ADDENDUM

PROJECT: Memorial Health Care Systems
2014 W Addn & Remodel / Radiology Addn & Remodel
Bid Package 2 - Building Construction
Seward, Nebraska

AD-2

DATE ISSUED: Thursday, August 7, 2014

From Sheet S2-2B	for CA use:
Drawing # S2-2B.1

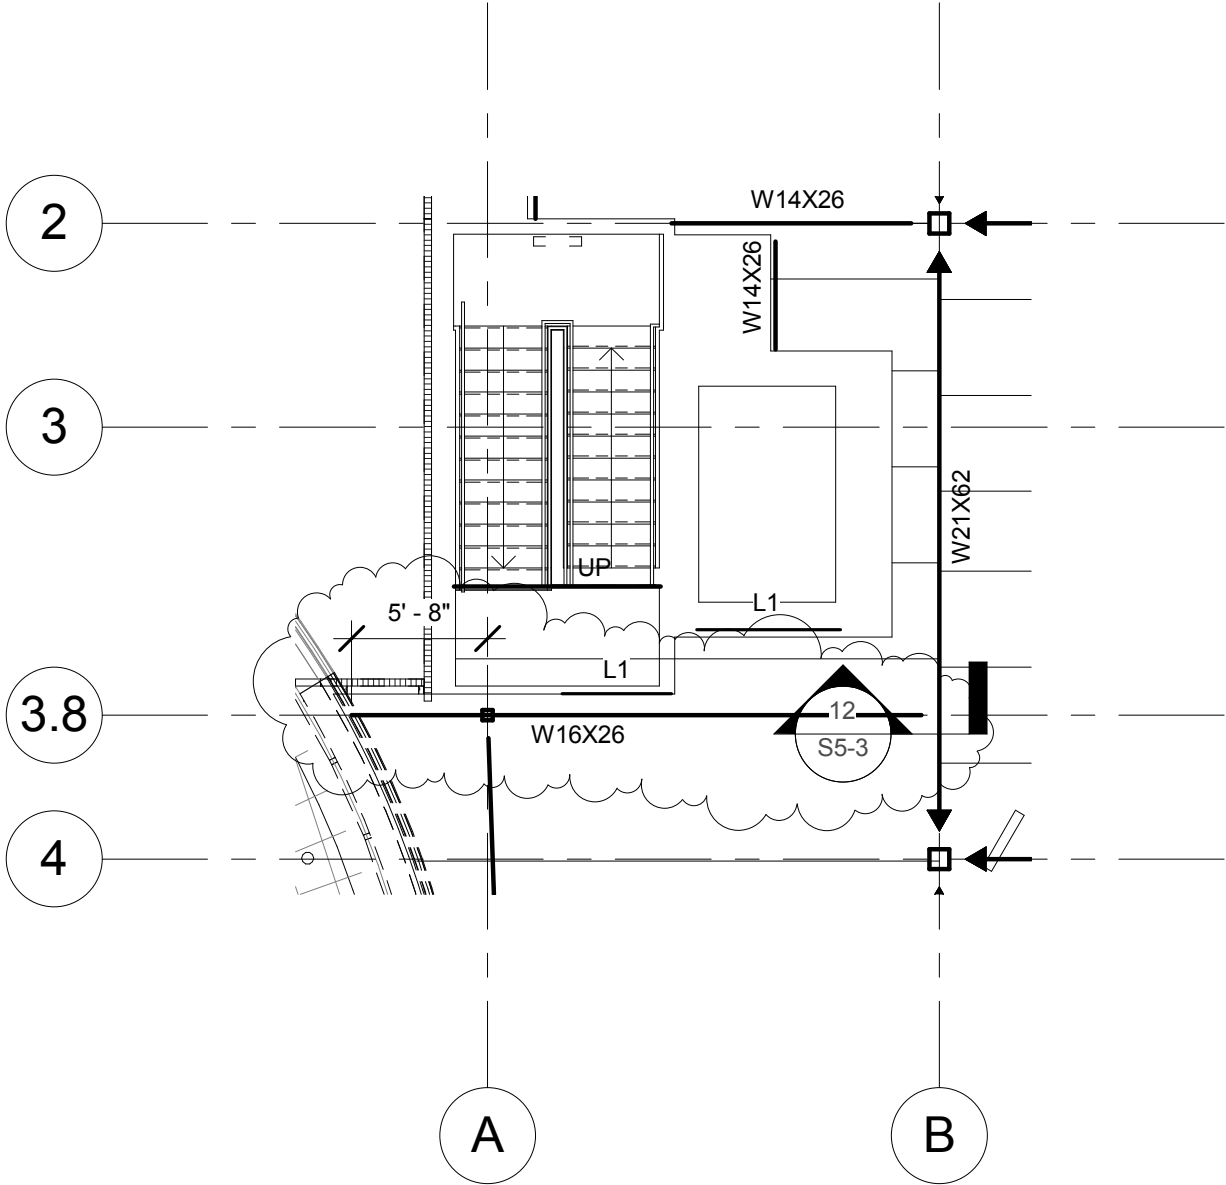
In reference to Sheet S2-2B, see partial framing plan S2-2B.1 attached for revision to Second Floor Framing Plan Area B.

From Sheet A1-3B	for CA use:
Drawing # A1-3B.2

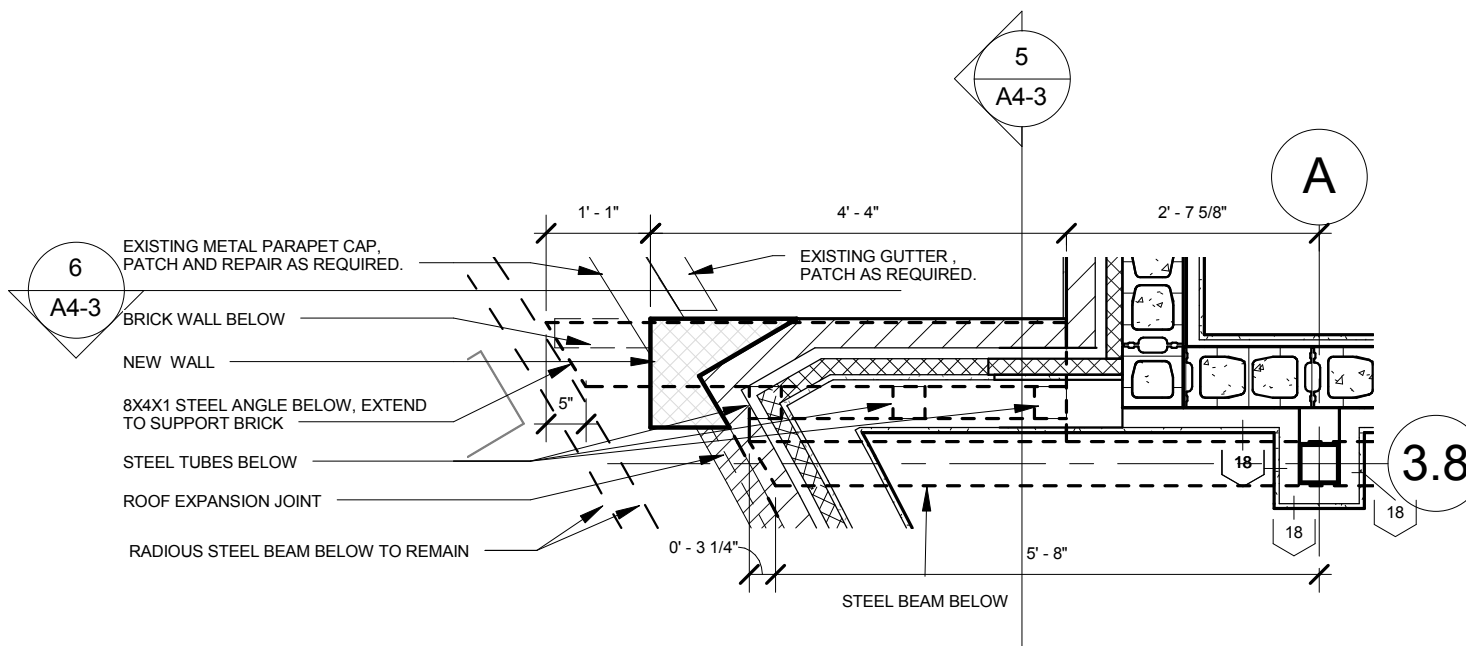
In reference to Sheet A1-3B, revise floor plan as shown on attached Supplemental Drawing A1-3B.2.

From Sheet A4-3	for CA use:
Drawing # A4-3.2

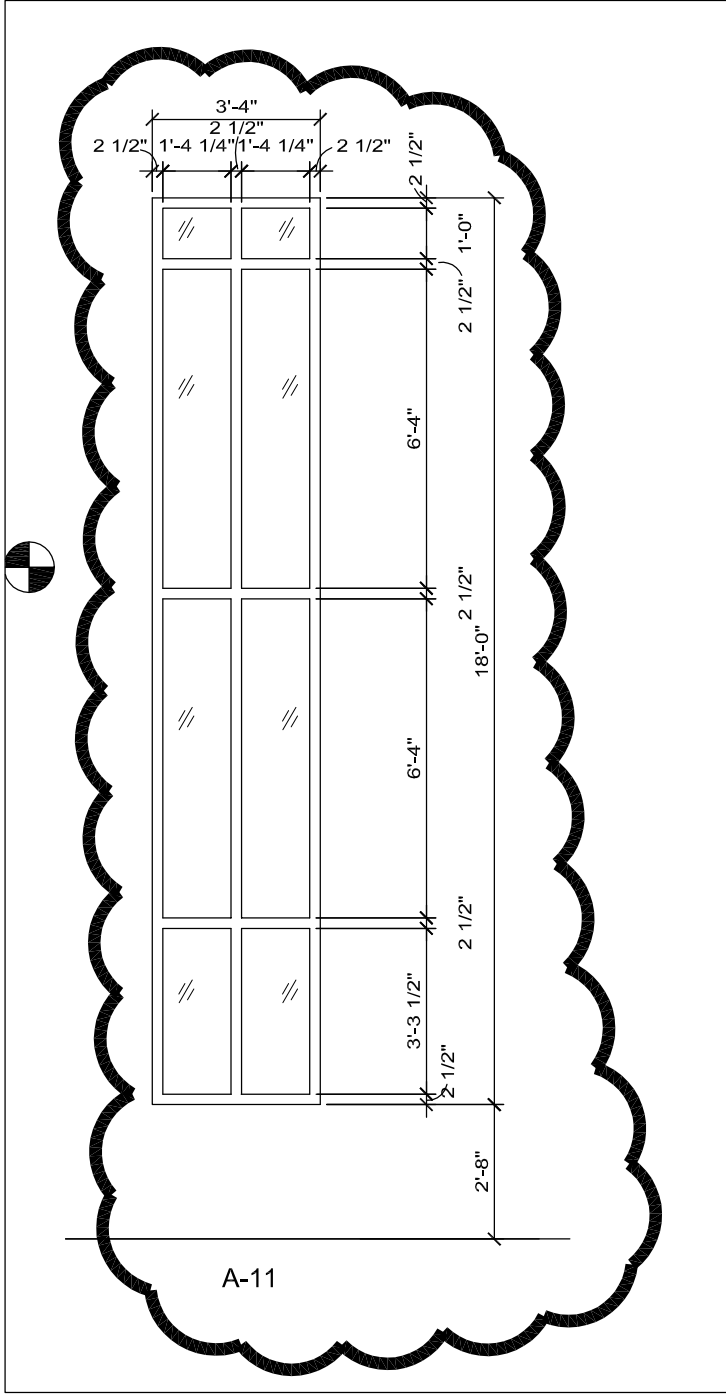
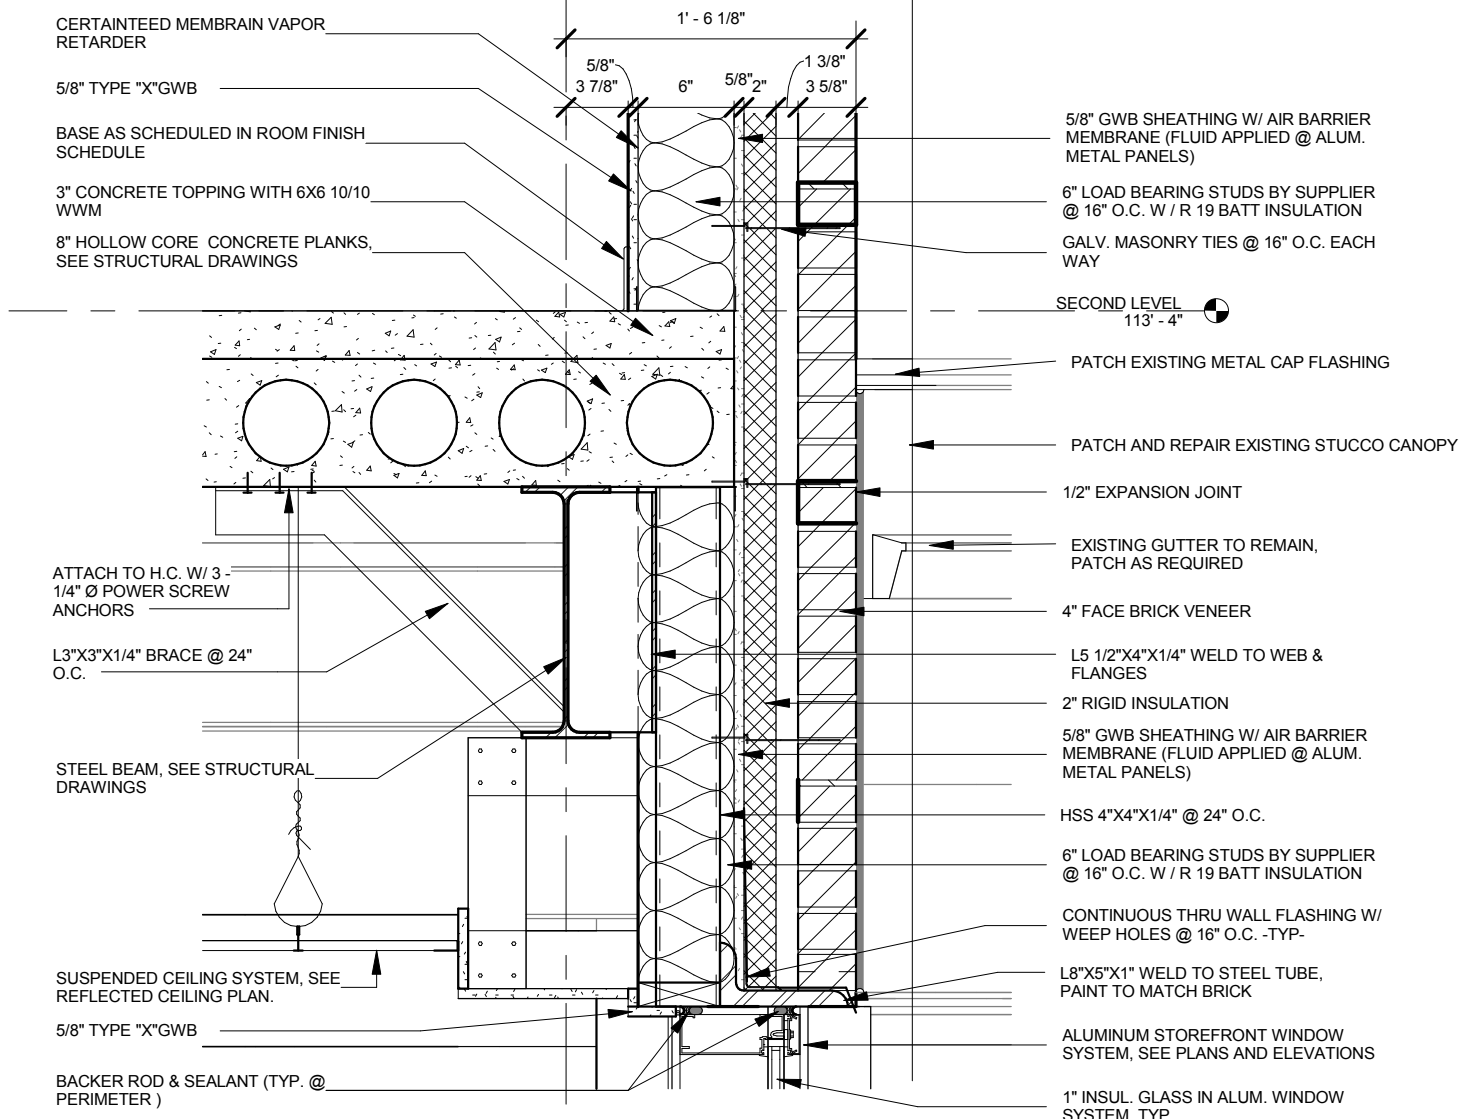
In reference to Sheet A4-3, add wall section as shown on attached Supplemental Drawing A4-3.2.

From Sheet A4-3	for CA use:
Drawing # A4-3.3

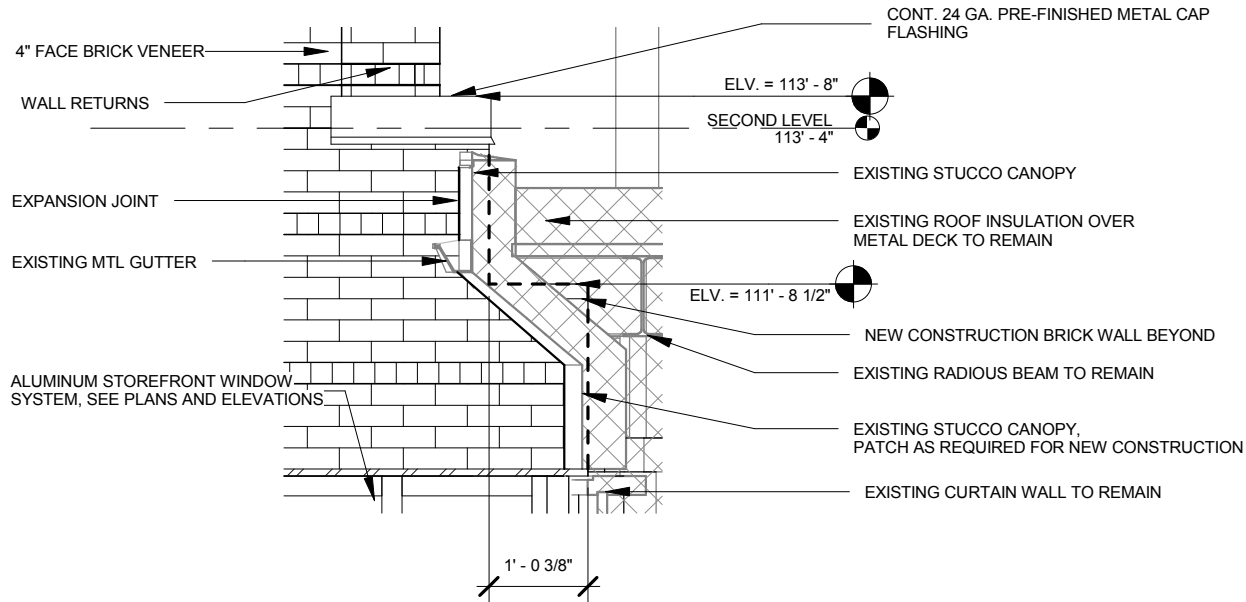
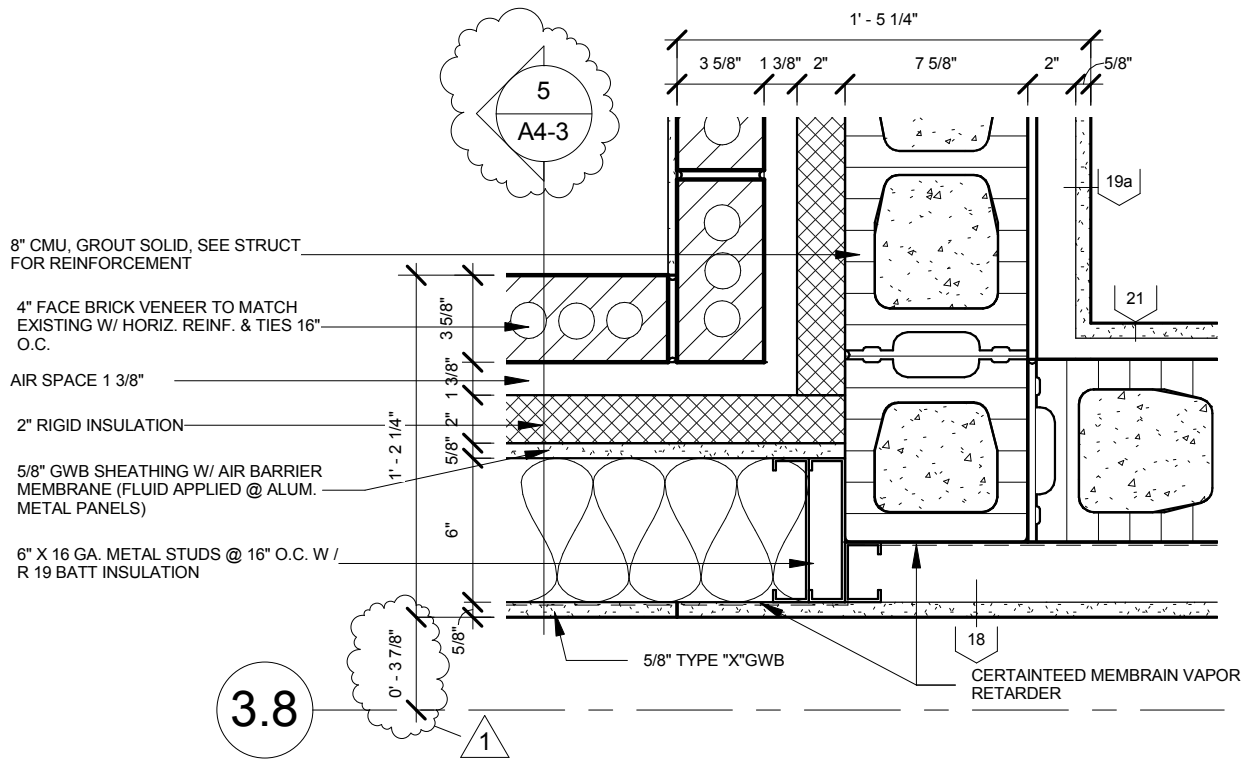
In reference to Sheet A4-3, add wall section as shown on attached Supplemental Drawing A4-3.3.

Drawing #
 E1-0B.1

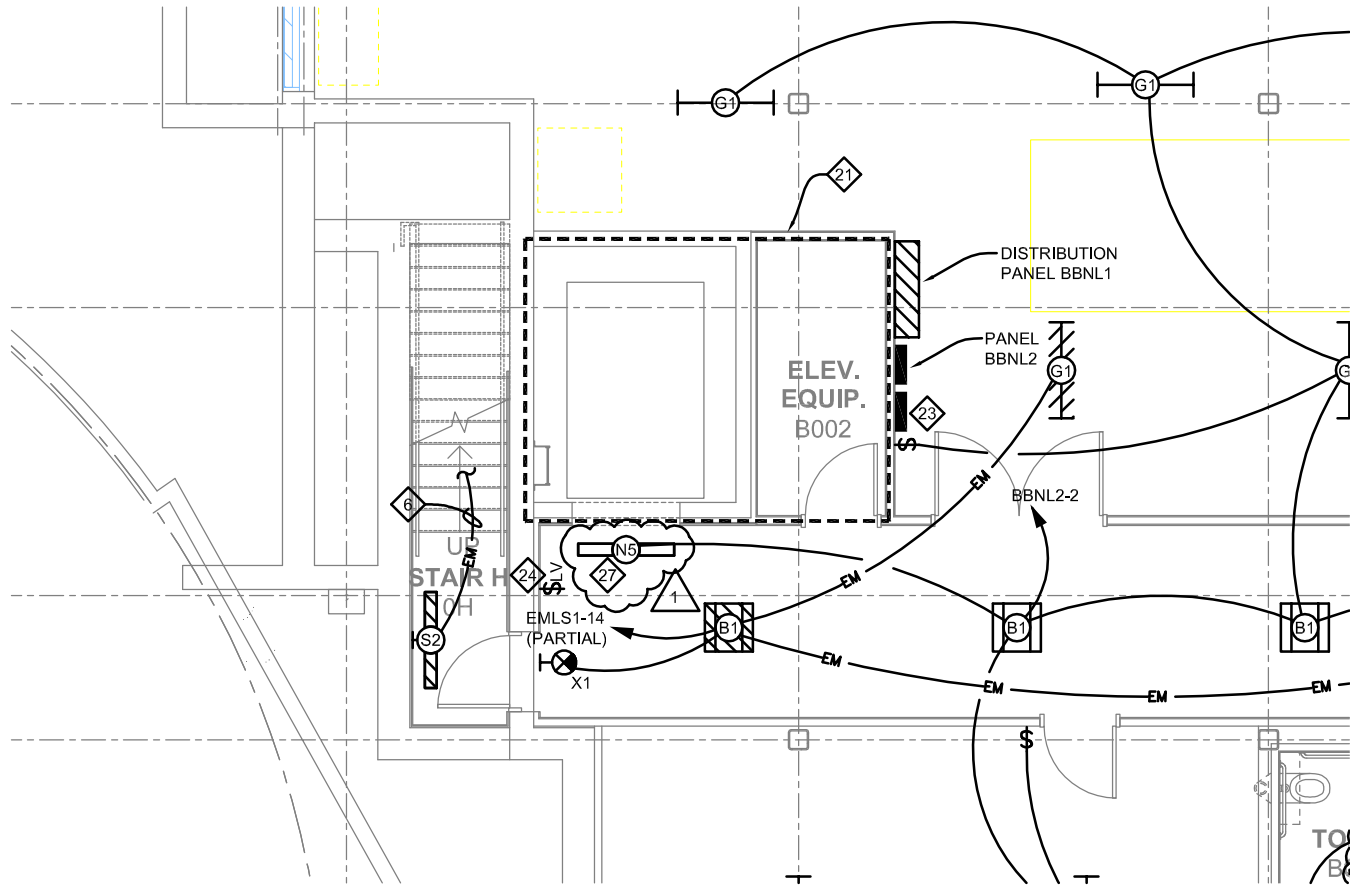
In reference to Sheet E1-0B, revise lighting to add fixture "N5" as shown on attached Supplemental Drawing E1-0B.1

Drawing #
 E1-1B.2

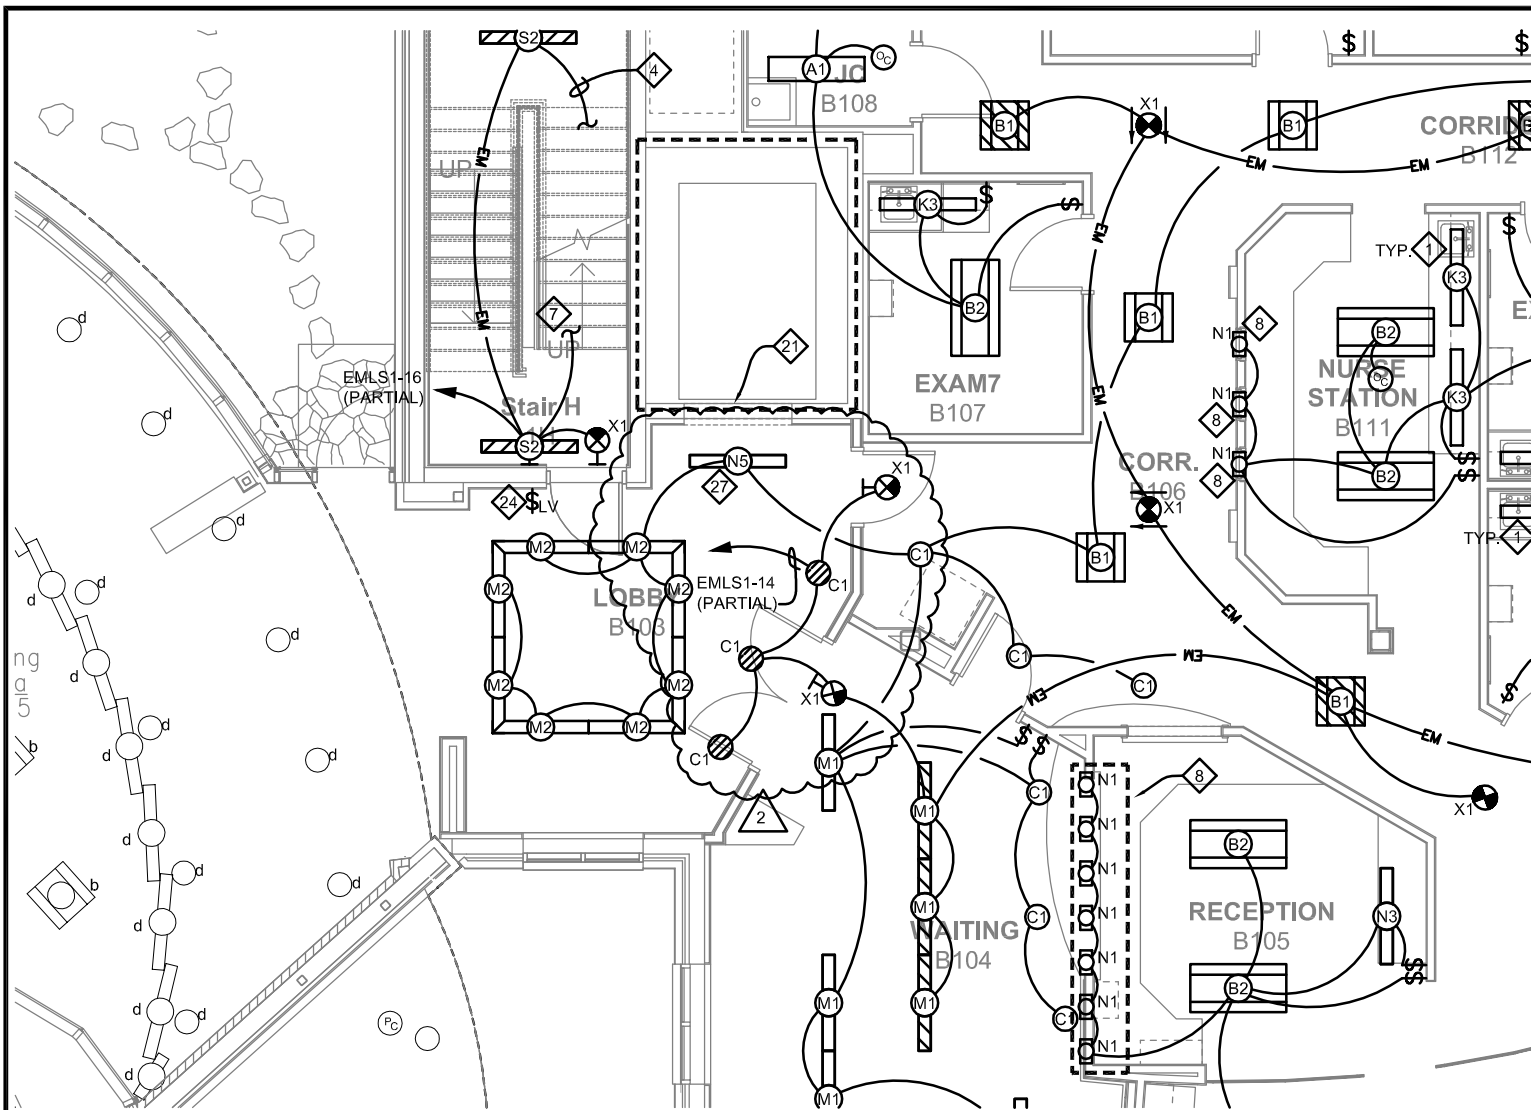
In reference to Sheet E1-1B, revise lighting to add fixture "N5" as shown on attached Supplemental Drawing E1-1B.2

27 MOUNT "N5" LIGHT FIXTURE CENTERED ON ELEVATOR DOORS, AND APPROXIMATELY 1'-6" FROM WALL AS SHOWN.

Drawing #
E1-2B.1

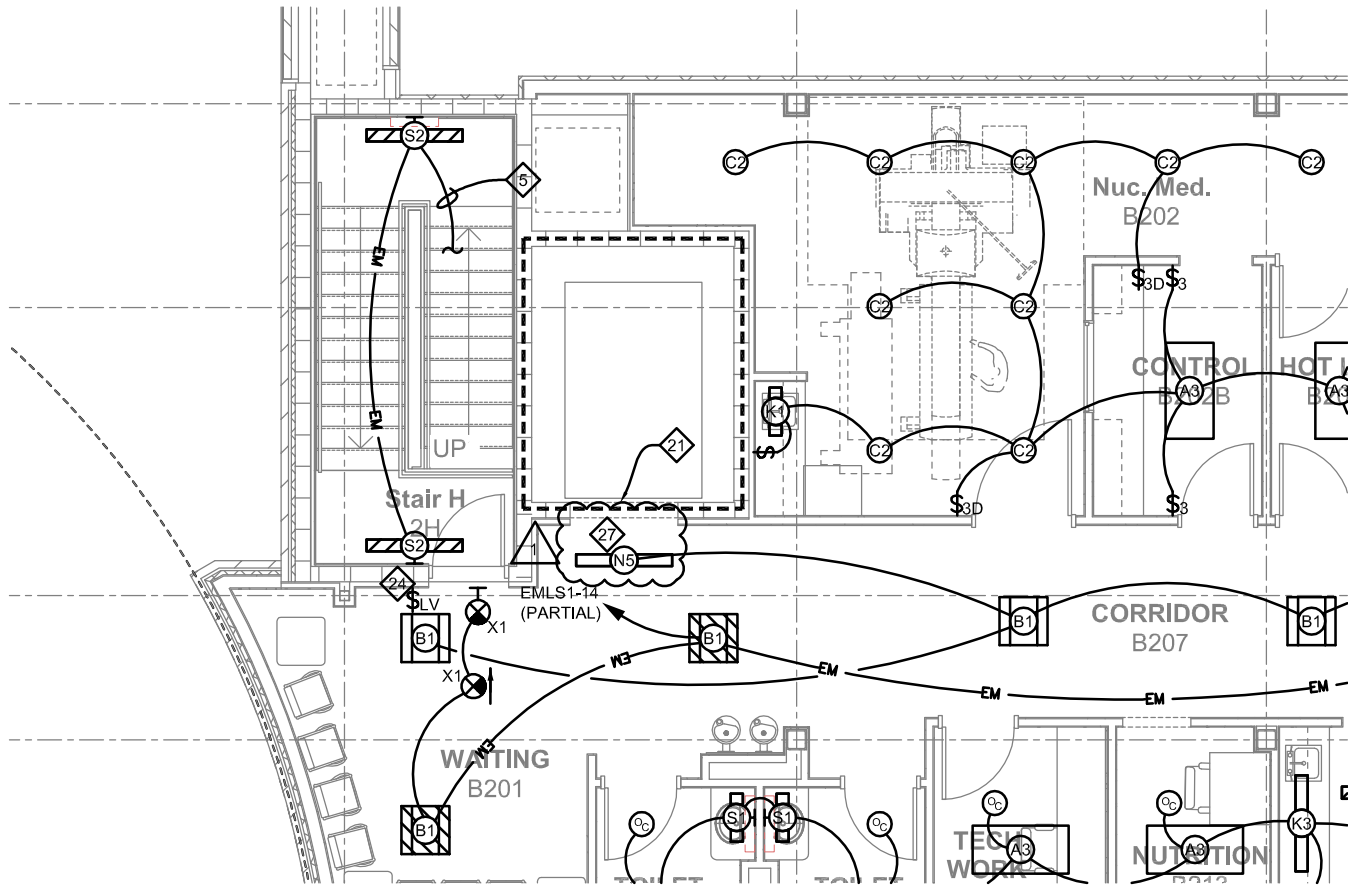
In reference to Sheet E1-2B, revise lighting to add fixture "N5" as shown on attached Supplemental Drawing E1-2B.1
